**RE: Supplement to R2 Space, Inc. XR Satellite Network Application,
IBFS File No. SAT-LOA-20200511-00042 (Call Sign S3067)**

This letter responds to requests for additional information concerning the above-referenced application made both during a June 3, 2020 conference call among Satellite Division staff and representatives of R2 Space, Inc. (“R2 Space”) and in follow-up correspondence from Merissa Velez dated June 9, 2020. The substance of each question posed during these discussions is set forth below followed by R2 Space’s response. As a result of the clarifications provided here, R2 Space had made some changes to the information provided in its Technical Annex (Exhibit A) and its Orbital Debris Mitigation Report (Exhibit B), complete revised copies of which are provided as attachments hereto in addition to other technical information that the Satellite Division has requested.

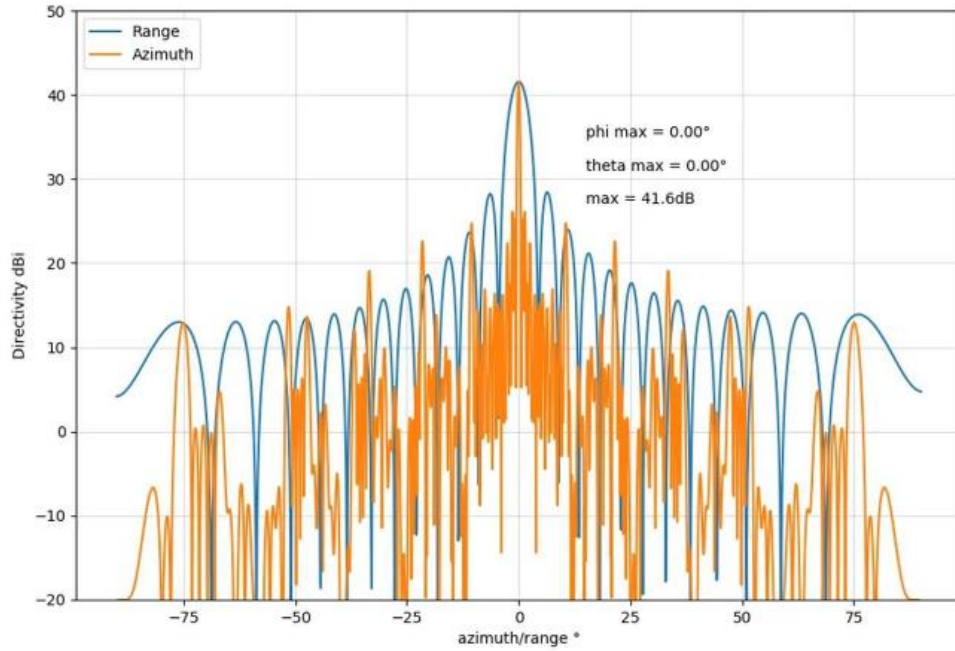
1. With respect to the requirement of the new Small Satellite Rules that there be a zero probability of human casualty from portions of the spacecraft surviving re-entry and reaching the surface of the Earth, provide clarification and demonstration that this requirement will be met.

R2 Space utilized NASA's DAS program to calculate the probability of objects surviving reentry and found that no individual components are expected to survive reentry. Below is a list of all XR-1 components along with their respective demise altitudes.

The DAS program outputs demonstrate that the probability of human casualty is 0 as all individual components are expected to break up far above the earth. Accordingly, the XR satellites comply with requirement 4.7-1. See Updated Exhibit B at 10-11.

SAR antenna beampattern (shown on next page):

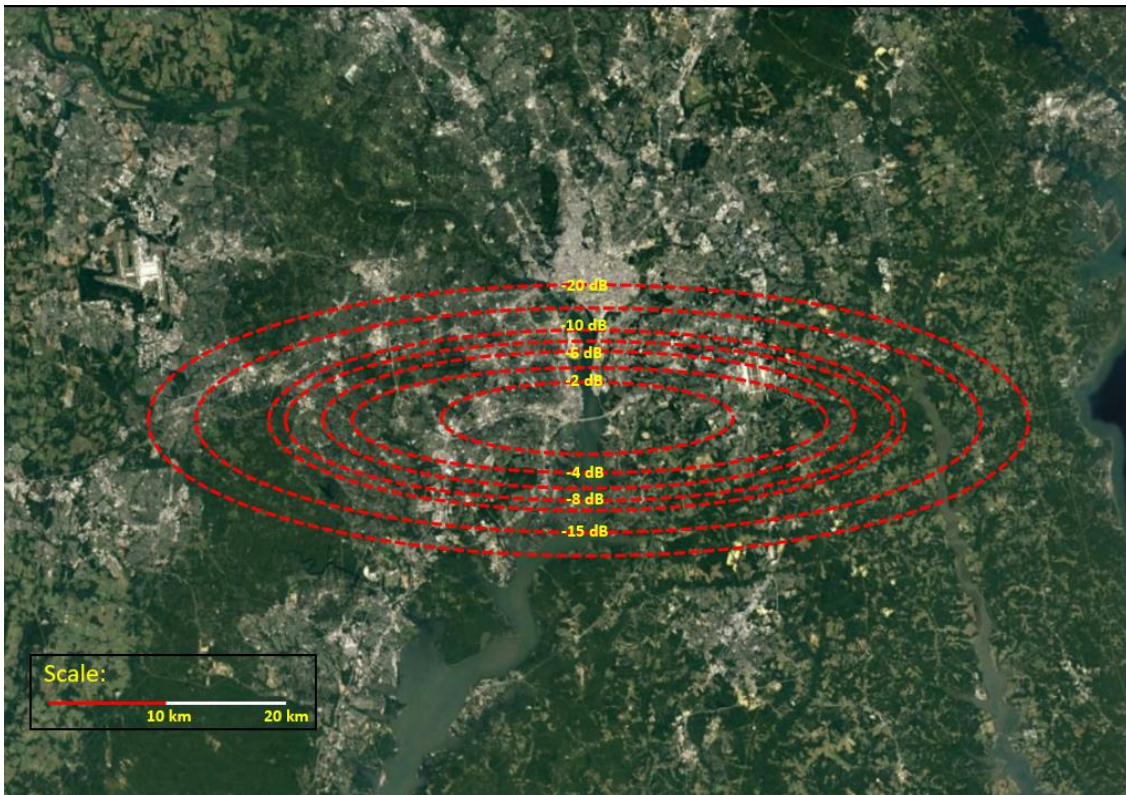
2. Provide antenna gain contours for each transmit and receive antenna beam, as described in Section 25.114(c)(vi)(B) of the FCC's Rules.
